**EC 360234
EVALUATION**

This EC (360234) evaluates the acceptability of discharging tritiated water from the Exelon pond, using the Interim Remedial Action Pumping System (IRAPS), pumping the tritiated water into the Circulating Water System Blowdown Line (CW BDL) and discharging it to the Kankakee River. The EC provides a description of new and existing components, revisions to existing systems and components and their operation and control. Additionally, the EC provides the basis and the methods that will be employed to ensure the plan is acceptable with regards to licensing and regulatory requirements.

CIRCULATING WATER BLOWDOWN LINE-ØCW09C-48"
 VACUUM BREAKER #2 VAULT
 EC 360234 REV. 000
 ALTERNATE CONNECTION FOR POND DISCHARGE

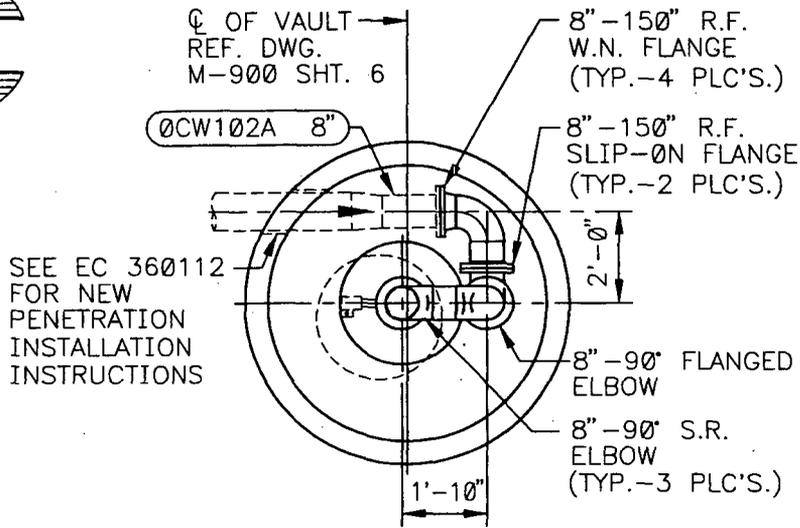
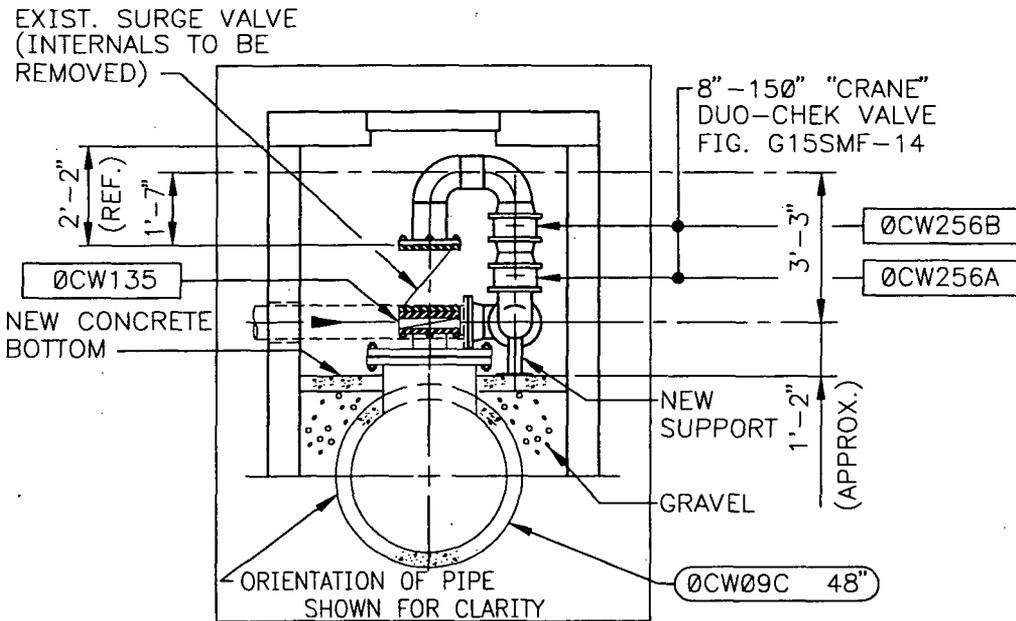
↑ IS this method #1
